Detailed Site Plan 9113 Baltimore Avenue

DSP-22015

STAFF REPORT

SUBJECT: Detailed Site Plan DSP-22015
9113 Baltimore Avenue

Figure 6: Wall sign located on the northwest corner of building

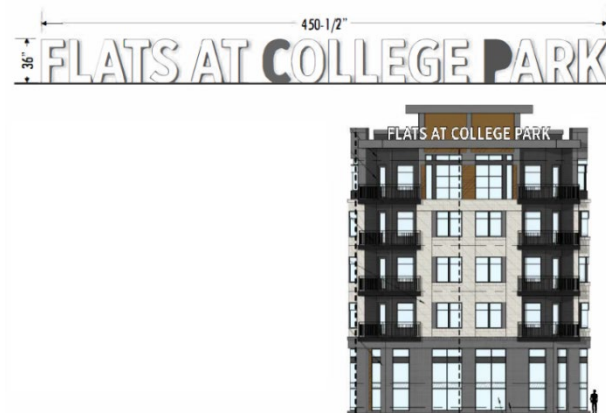
The applicant proposes multiple building-mounted signs: one back-lit, channel-letter, building-mounted marquee sign will be located on a projecting metal canopy at the northwest corner of the building, facing the intersection of US 1 and Delaware Street, as shown in Figure 6. Another vertical, back-lit, sign will be mounted on the western building façade that will be visible from US 1, as shown in Figure 7. Other building-mounted, back-lit, channel-letter signs are proposed along US 1 and Cherokee Street, above the residential, commercial, and parking garage entrances. No sign is proposed for a residential entrance located off Delaware Street. In addition, no sign is proposed at the southwest corner of the building, to identify it for travelers coming up US 1. Additional signs should be provided at both of these locations. The submitted sign details for the project includes the square footage for each sign, but not all the details required to fully evaluate conformance with the sign requirements of the D-D-O Zone (page 254 of the sector plan). The maximum gross area of signs, on a given façade, shall not exceed 10 percent of the façade area of the commercial portion of the building, though architectural signs or signage painted on a building façade or mounted on the roof may exceed this limit, in certain cases. A condition has been included requiring the applicant to demonstrate conformance with the applicable sign requirements.
